One Earth Solar Farm

Consultation Report

Appendices J-1 and J-2: Regard had to statutory consultation responses

[EN010159/APP/5.1.1]

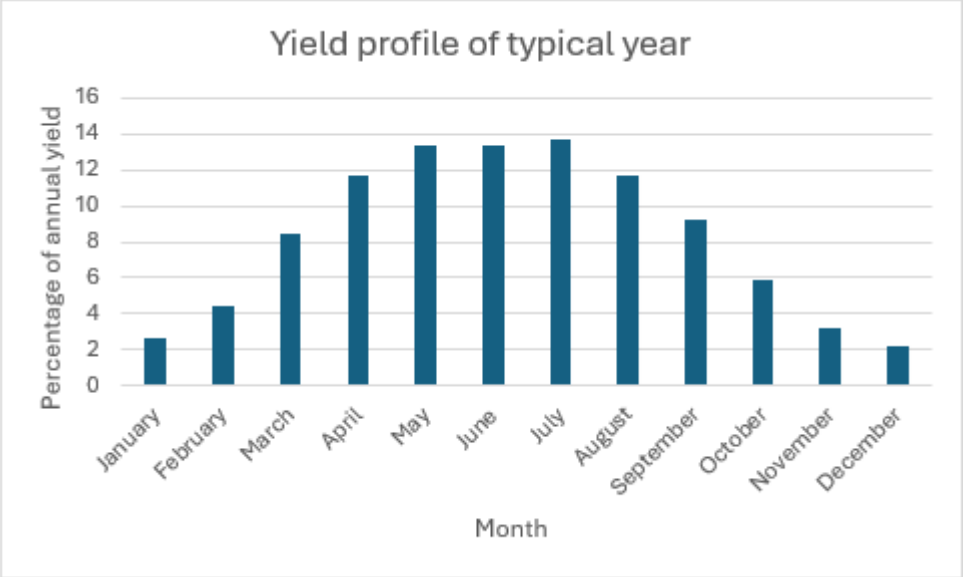
10. **15.19. Our Project will generate and export an estimated 1,000 GWh (gigawatt hours) of renewable electricity each year.**
    Q8. Do you have a monthly breakdown of this?

Please see below, this reflects the typical solar generation profile.
